Project Reading Metropolitan
LPA ref 182252
From Francesca Whitfield/Adrian Cole
Date 19 July 2019

Transport Addendum

Table 1: Response to comments raised by Reading Borough Council's Transport Development Control Group

Basement Plan

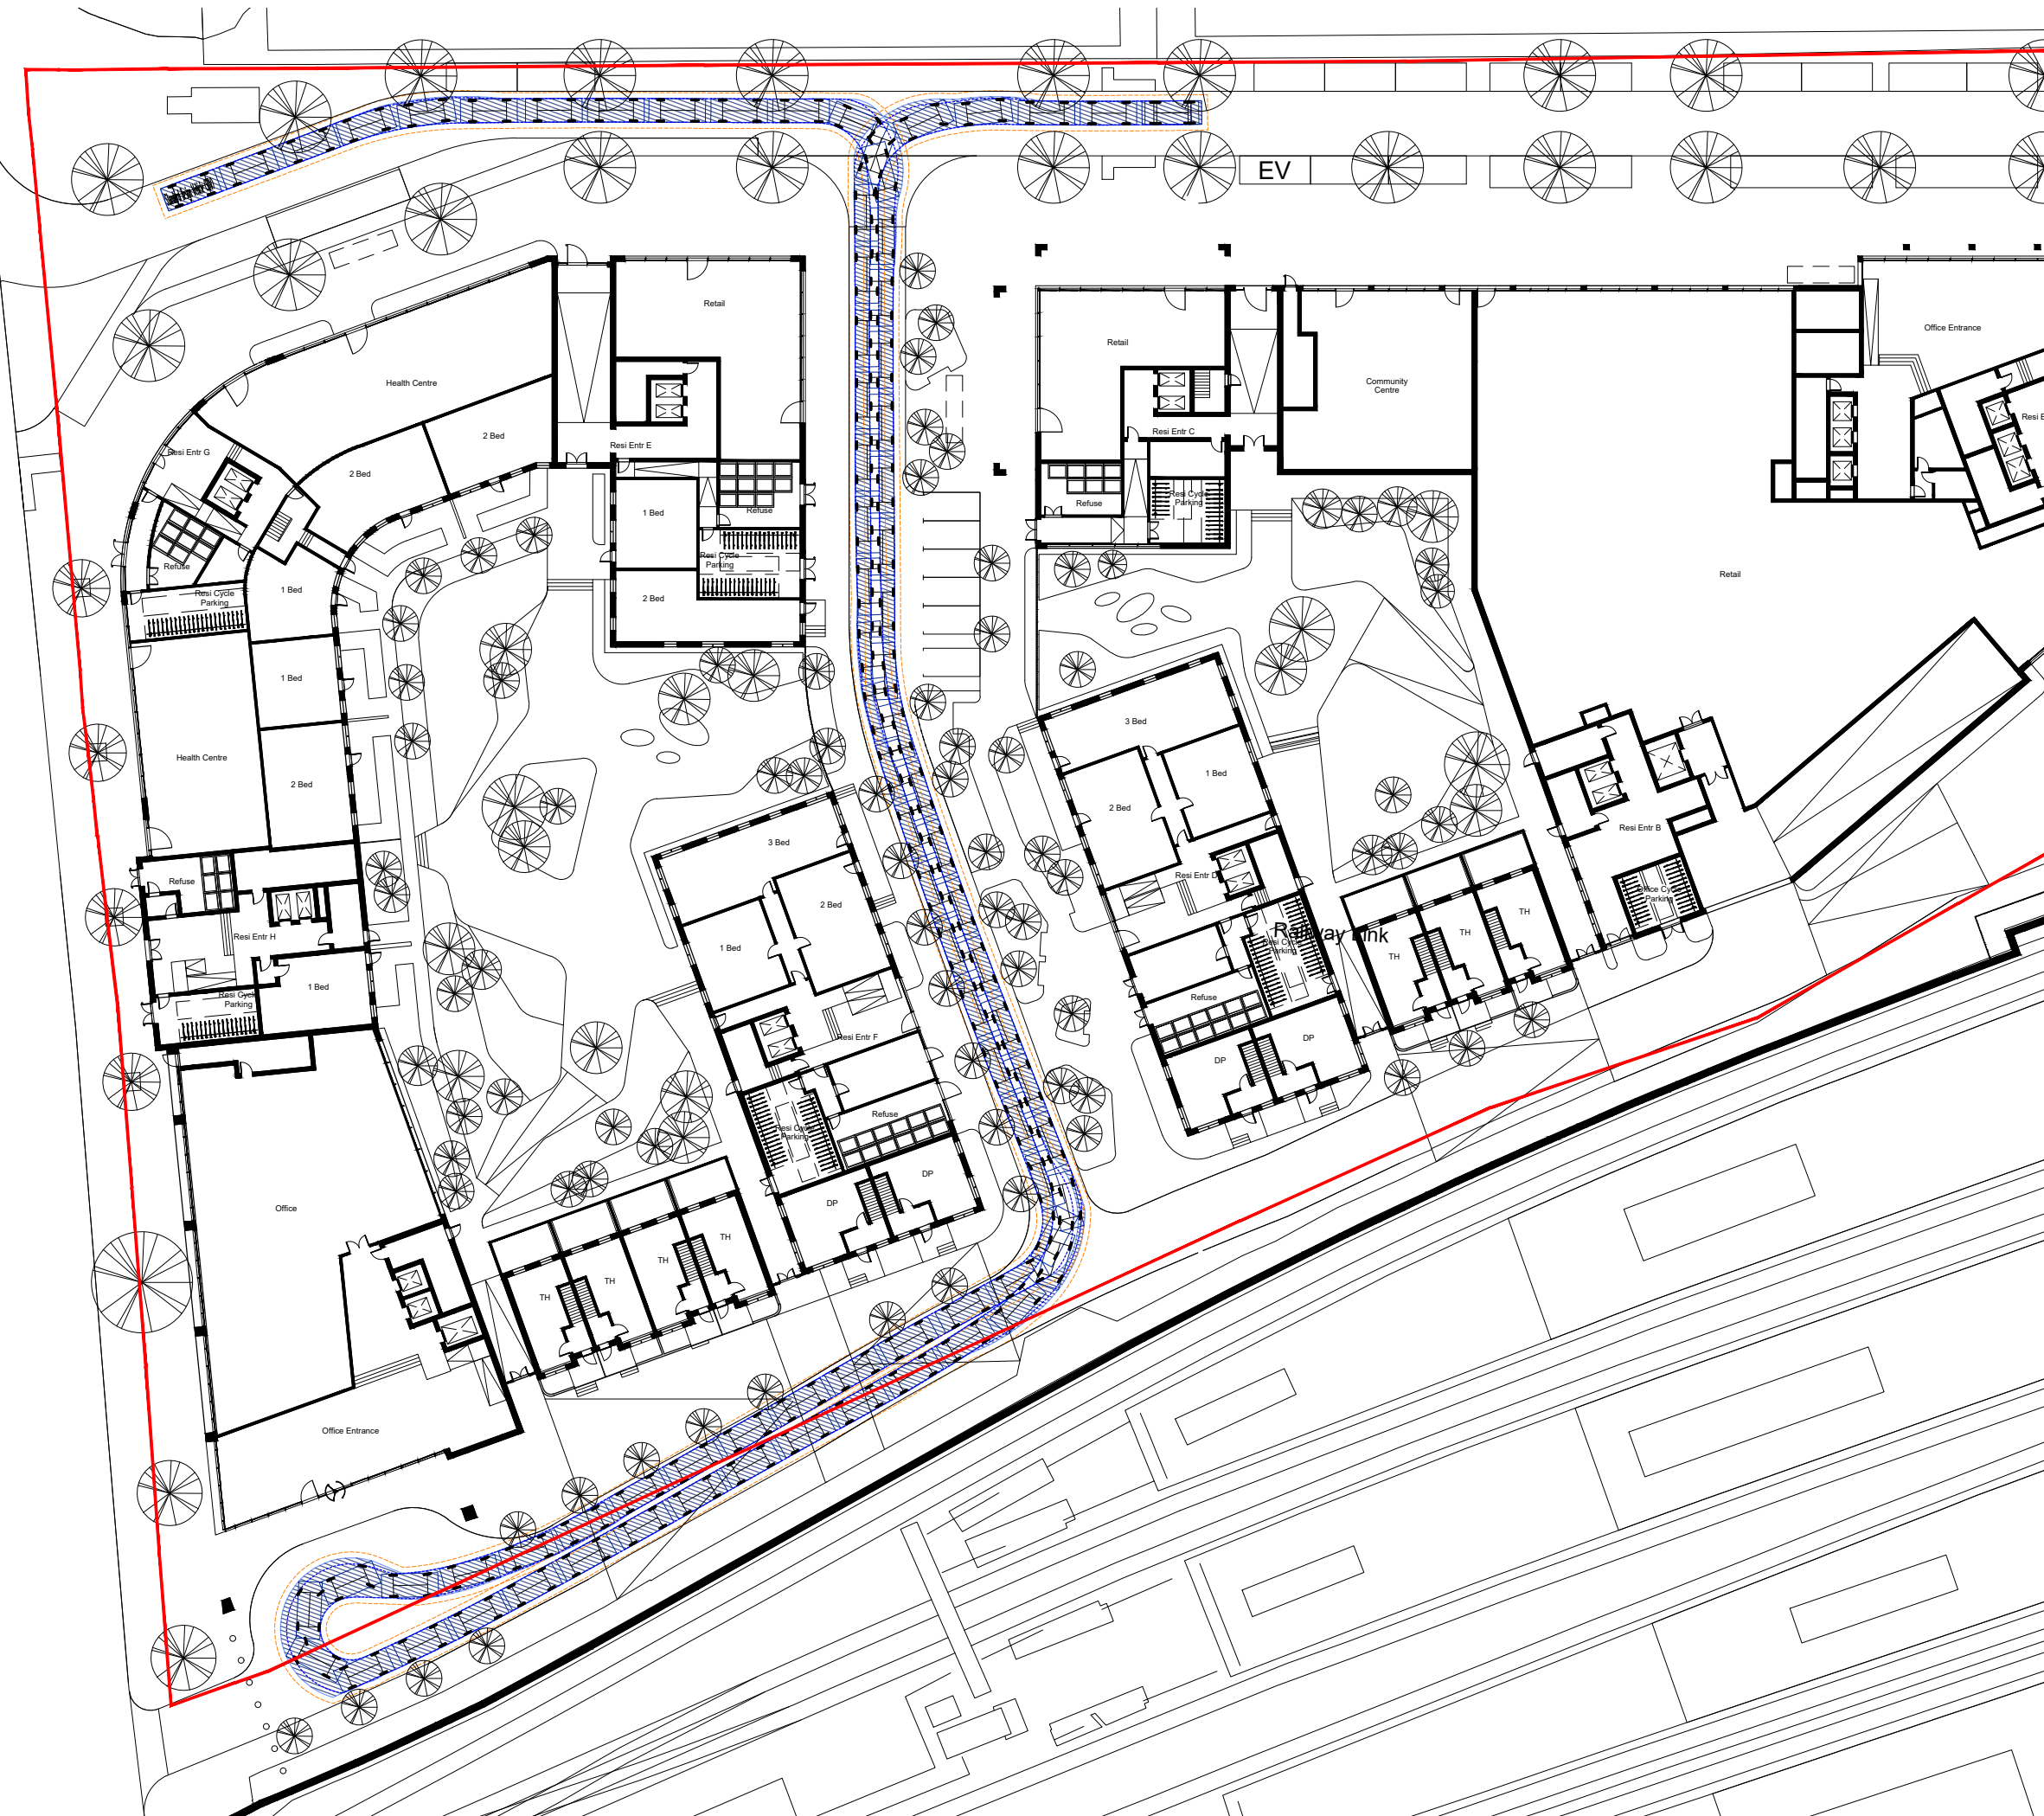
Topic	RBC Comment	Response
Parking	The parking layout is generally acceptable however there are 5 bays within the basement to the north of the energy centre that are not provided with the required 6m forecourt depth. A revised drawing is required ensuring that are parking spaces are to the correct layout requirements.	Please refer to the updated basement layout plan in Appendix A . (TP Bennett Drawing A11113 C 2 099 Revision P4).
	Eight disabled parking spaces are available on the Site. Although the TA stipulates two being located at basement level and are designated for residential use the submitted plans identify four spaces. The TA also stipulates that six disabled bays at located at street level on Metropolitan Road and The Avenue, however the submitted plans only identify where one of these spaces would be located. It should be noted that disabled bays should be located as close to and within easy access to where they wish to go, the locations should therefore be thoughtfully positioned. Revised plans should be submitted to clarify this.	Please refer to the updated basement layout plan in Appendix A . (TP Bennett Drawing A11113 C 2 099 Revision P4).
